3.9 GHz Cryomodule Design - Fresh Look Summary

Josh Kaluzny and Camille Ginsburg, for the 3.9 GHz cryomodule design team

May 30, 2019

Abstract

Figure 1: Upstream gate valve region: tunnel wall side (left), and tunnel aisle side (right).

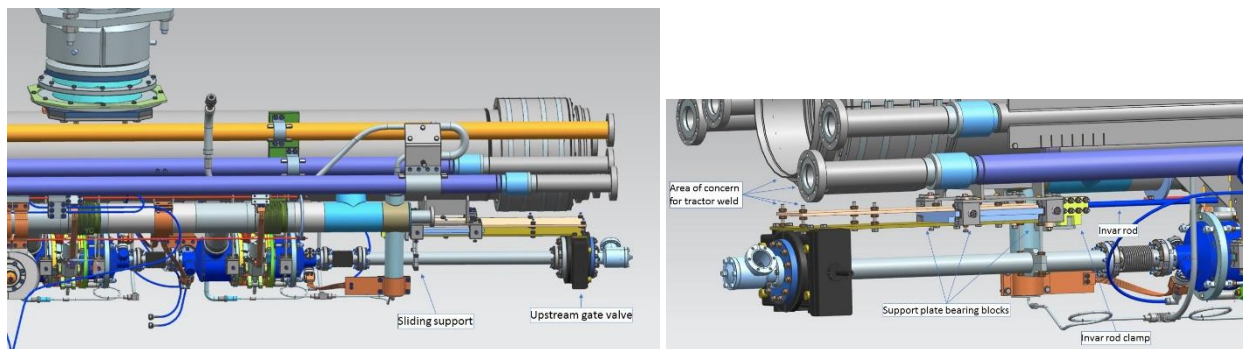
The upstream gate valve (US GV) support (Fig. 1) was investigated. This end doesn’t move much through thermal contraction, only about 4.5 mm, because this is the fixed support post end. A sliding support was added to the beam tube that was cantilevered off of the US GV. The beam tube and the support are the same material, so they have the same thermal shrinkage, but the support needs to be sliding because the relative dynamic cooling is not known and would be difficult to predict accurately enough. A set of plates attaches the US GV to the HGRP, through bearing blocks which provide adequate travel for thermal contraction (4.5 mm). An anti-roll plate (not shown) has been added on the invar rod clamp to restrict the invar rod from rotating. The possibility of removing the sliding support

and hard connecting the gate valve to the 300mm pipe was discussed and rejected as not necessary. Space between the HGRP and the two bolts at the top of the plates supporting the US GV were checked and confirmed for adequate tractor weld clearance.

Figure 2: Cavity supports for 3.9 GHz cavities (left), and for 1.3 GHz cavities (right), for comparison.

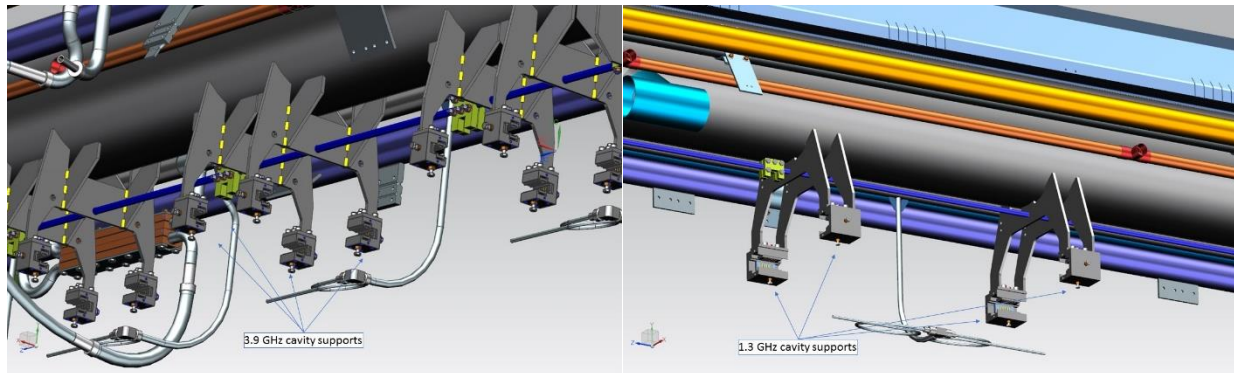
The 3.9 GHz cavity supports (Fig. 2) consist of only one plate coming down from the GHRP, per cavity side, whereas for the 1.3 GHz cavities, the supports have two plates. The roller bearings blocks, one per cavity lug, are similar but not the same as for the 1.3 GHz cavities.

Figure 3: Model of the cryomodule downstream end showing the liquid-level flex hose.

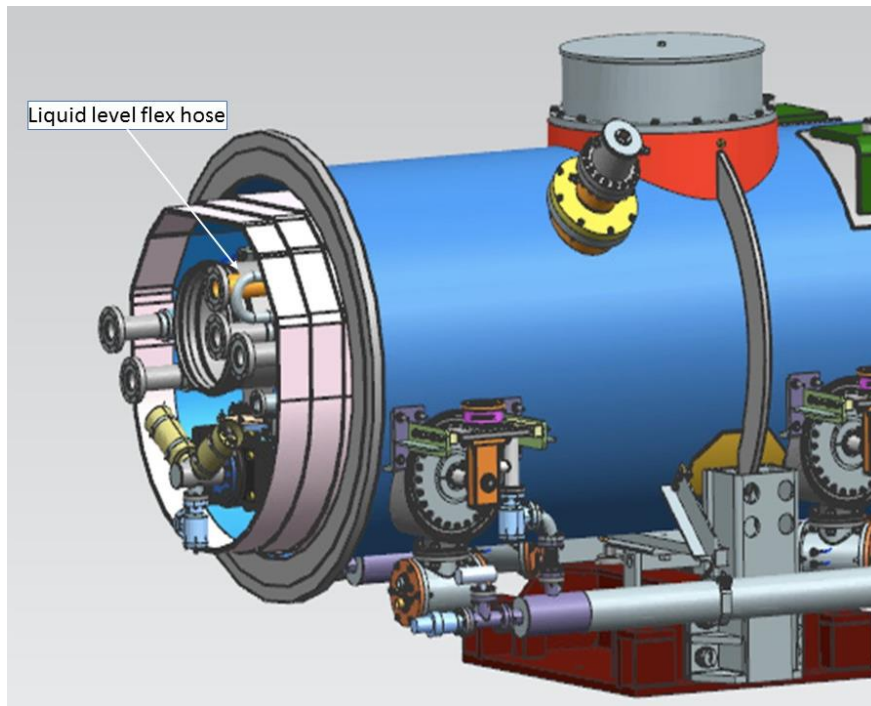
For the downstream end (Fig. 3), the liquid-level flex hose may interfere with cryogenic pipe welding, maybe more so than for 1.3 GHz.

- 1) Check whether the liquid level can flex hoses interfere with welding the interconnect.

Figure 4: Cavity simulation showing area of maximum stress (left), and model showing the same location (right).

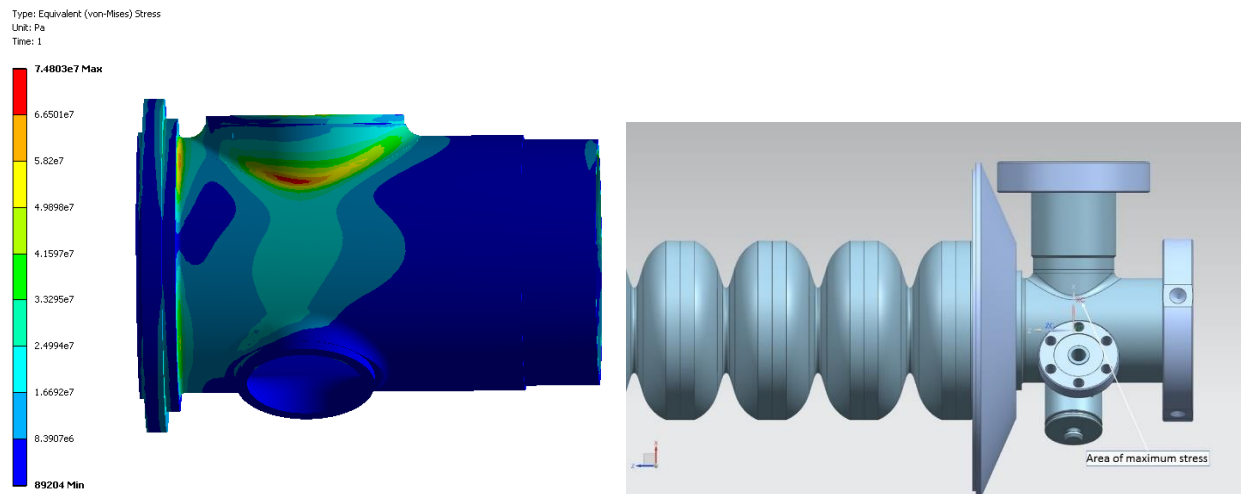
The simulation (Fig.4) shows a high stress concentration in the niobium at the coupler tube with 1.5 G loads. From the stress standpoint, the levels are acceptable, but fatigue could be an issue, e.g., during shipment. This motivates a shaker-table test. If the cavity/coupler passes the shaker table test with a safety factor on acceleration and cycles we do not need additional support (which would be from the warm-to-cold coupler flange to the two-phase chimney (50K).

- 1) Perform bellows fatigue EJMA calculations for all four bellows: two coupler bellows (one inner, one outer), cavity string bellows, and 2-phase pipe bellows.
- 2) Perform a shaker table test of the actual cavity/coupler connection.
- 3) Find the minimum thickness of the pull-out at the coupler tube with an ultrasonic probe, to ensure the necking during fabrication leaves adequate material in this area.

Figure 5: Cavity end-group detail showing HOM can for 3.9 GHz cavity (left), and 1.3 GHz cavity for reference (right).

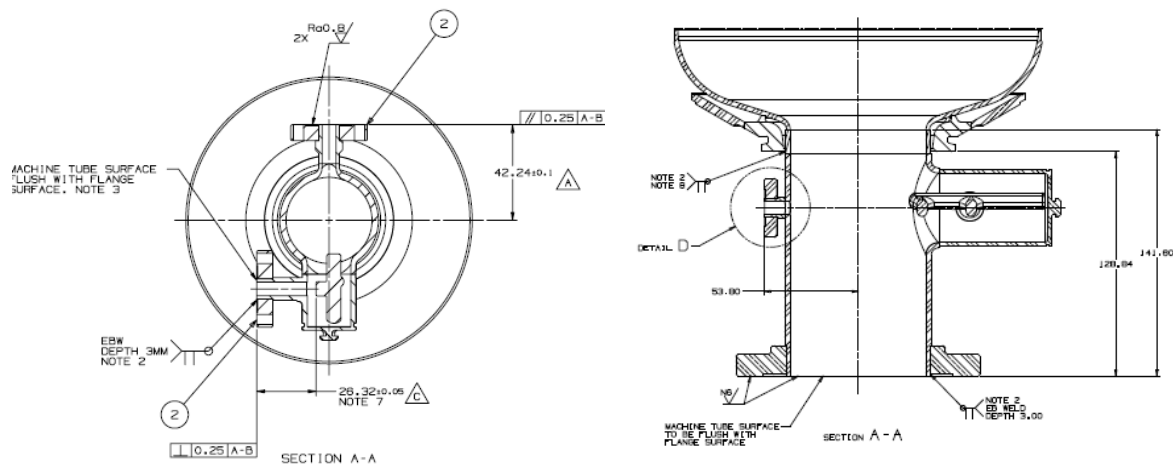
A comparison of the 3.9 GHz cavity HOM with that of the 1.3 GHz cavity (see Fig.5) demonstrated that the HOM's have many similarities (same ceramic portion of the feedthrough, same flange size), and some differences (antenna has a smaller diameter and is shorter, the F-part is different). The same RF cable will be used as for 1.3 GHz. The knob stability on the HOM can is expected to be better for the 3.9 GHz case, and specifically should be less sensitive to detuning by moving the RF cable connected at the flange. The shrinkage which moves the 3.9 GHz cable will be different (less) in this cryomodule. It will be more difficult to tune the HOM notch frequencies after the vacuum vessel is installed, because there are no tuner access ports. The HOM can magnetic shielding caps are finalized, ordered and received, but the received caps have yet to be checked on a real cavity to make sure they don't put undue pressure on the HOM tuning knob, and detune the notch frequency.

- 1) Monitor the notch frequency during assembly to confirm no assembly activities cause detuning.
- 2) Fit up the magnetic shielding caps for the HOM cans to ensure installation doesn't detune the HOM's.
- 3) Check that the HOM notch tuning device will fit properly to the full dressed cavity assembly, including cables.
- 4) Check/confirm strain relief of RF cables connected to HOM's.
- 5) Review cavity roll alignment procedure.
